Reviewer comments in *italics*Author Responses in **bold**

Reviewer #1 comments https://doi.org/10.5194/egusphere-2025-1186-RC1 Review of "A low-cost approach to monitoring streamflow dynamics in small, headwater streams using timelapse imagery and a deep learning model"

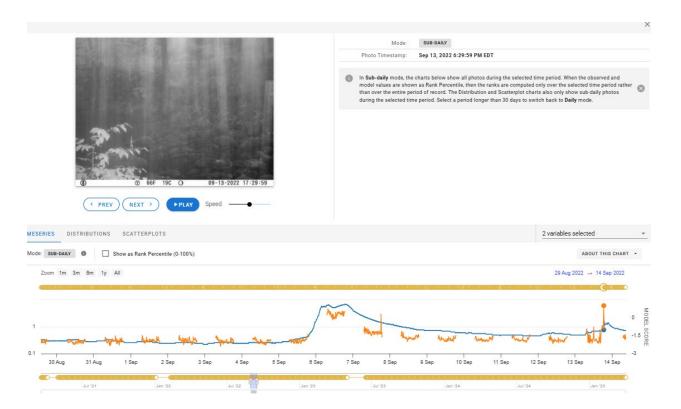
2. Figure 6: there appears to be a large spike in predicted model score towards the end of the time series (see inset) that is not matched by a corresponding streamflow observation. Can the authors speculate as to what might be causing this discrepancy? Also, the yellow text in Figure 6 is difficult to read, consider changing color.

Yes, there are some outlier spikes at the individual 15-minute predictions at the end of the inset time period (September 13th, 2022). A review of the imagery and model results data (shown below and interactively visible here: https://www.usgs.gov/apps/ecosheds/fpe/#/explorer/14) shows that rain and low light resulted in infrared camera flash being reflected back to the camera, resulting in an outlier prediction. However, the mean value for the day is only slightly affected. We changed the yellow color to green for better visibility.
